### **Application Summary:** [DC/21/00641](#)

Proposal: Submission of details (reserved matters) in relation to outline planning permission DC/18/00723 appearance, landscaping, layout and scale for the erection of up to 51 dwellings, highways improvements including widening of Turkeyhall Lane, provision of public open space and associated infrastructure Land to the East of Turkey Hall Lane Bacton.

### **Objection to DC/21/00641: Submission of details (reserved matters) relating to outline planning permission DC/18/00723**

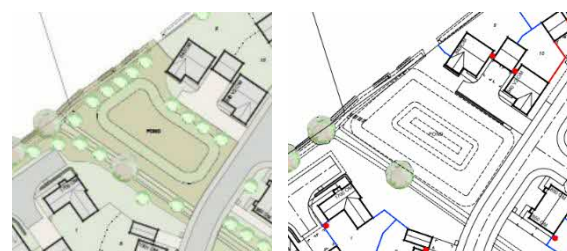
1.7 Similarly the proposed pathway onto the Open Spaced Area between the side of plots 24 and 25 is a concern as it opens up the rear of these properties to also be more susceptible to burglary and it heightens the possibility of it being a gathering point for people for antisocial behaviour. It cannot be clearly identified how this area will be perimetered on each side as there appears to be what looks like hedging by the side of either plot and plot 25 will encompass a 1.8m high brick wall, whilst plot 24 will have a rear 1.8m high wooden fence. It would be preferred if this design can be altered, by either moving it to another area, or at least opening it up to be more open to surveillance as it is a real concern. A number of similar footpaths in other areas with hedging have historically been set on fire, so if vegetation is proposed along either side of this pathway it is strongly recommended it is not and there is still the problem of the hedging at the rear corners of plot 24 and plot 25. (SBD Homes 2019, pages 15, Para 8.9 refers).

1.8 The design is also a concern from the point of view the footpath opens up the rear of plots 21-26 and plot 31 to be more vulnerable to unlawful incursion and this Open Area if not opened up to lawful activity such as dog walking, walking and running will doubtless become an area for people to congregate and cause antisocial behaviour, as well as possible drug taking. Footpaths should be at least 3m across to allow people to safely pass one another without infringing on personal space and accommodate passing wheelchairs, cyclists and mobility vehicles. These areas also need to have low growing vegetation around them so that an offender cannot conceal themselves and the area needs to have lighting to make users feel safe to use them (SBD Homes 2019 (V2), pages 14-16, Paras 8.1-8.17 refers).

1.9 The Open Space area by a pond and the side of plots 1 and 8 is a concern, as again there is no surveillance from any where on the north eastern side of these properties and could well be an area for people to congregate and cause antisocial behaviour. It is presumed the pond area will be fenced or railed off?
